# Access Compliance Report

## Public Rights-of-Way

### (Curb Ramps)

Intersection ID: 29122	Main Street: CANDLE_LEAF_CT	Cross Street: CRISP_WOOD_LN	Location: SE
ADA ID: 8DB6AFF94455	Ramp Type: Perpendicular Diagonal	Initial Pass/Fail: Fail	Overall Compliance: No
Severity Score: 12.5			
Codes/Mitigation Info/Possible Solution		Field Measurements/Component Compliance

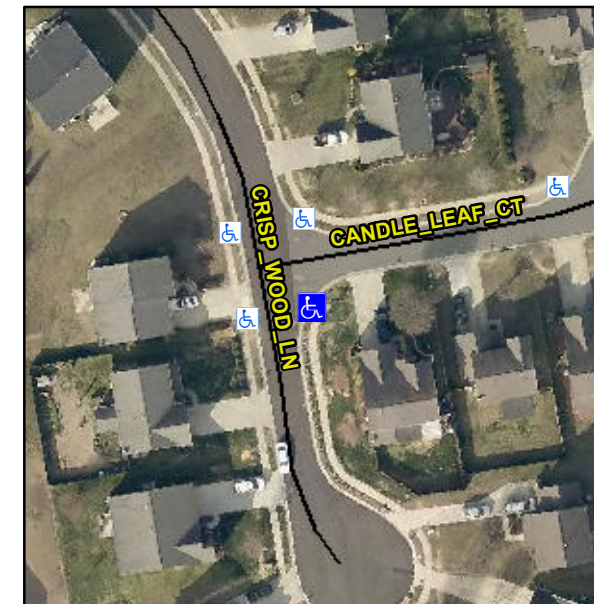
**Remove & Replace Curb Ramp With Two New Directional Ramps or Equivalent.**

**Not Found, R304.5.3**

Compliance	Description	Data	Compliance	Description	Data
N/A	Ramp Length (in)	50.0	Yes	Ramp Slope (%)	6.5
Yes	Ramp Width (in)	48.0	No	Ramp XSlope (%)	5.8
N/A	Flare Type LT	N/A	N/A	Flare Type RT	N/A
N/A	Flare Slope LT (%)	N/A	N/A	Flare Slope RT (%)	N/A
N/A	Flare Traversable LT?	N/A	N/A	Flare Traversable RT?	N/A
N/A	Landing Length (in)	N/A	N/A	DWS Provided?	N/A
N/A	Landing Width (in)	N/A	N/A	DWS Contrast?	N/A
N/A	Landing Slope (%)	N/A	N/A	DWS Length (in)	N/A
N/A	Landing X Slope (%)	N/A	N/A	DWS Full Width?	N/A
N/A	Landing Curb? (Y/N)	N/A	N/A	DWS Offset (in)	N/A
N/A	Shared Landing?	N/A			
N/A	Gutter Ponding?	N/A	N/A	Gutter Slope (%)	N/A
N/A	Gutter Lip Ht (in)	N/A	N/A	Gutter X Slope (%)	N/A
N/A	Painted X Walk1?	No	N/A	Painted X Walk2?	No
	X Walk 1 Direction	To N		X Walk 2 Direction	To W
N/A	X Walk 1 Width (in)	N/A	N/A	X Walk 2 Width (in)	N/A
	X Walk 1 Slope (%)	2.2		X Walk 2 Slope (%)	5.4
	X Walk 1 X Slope (%)	7.6		X Walk 2 X Slope (%)	3.0
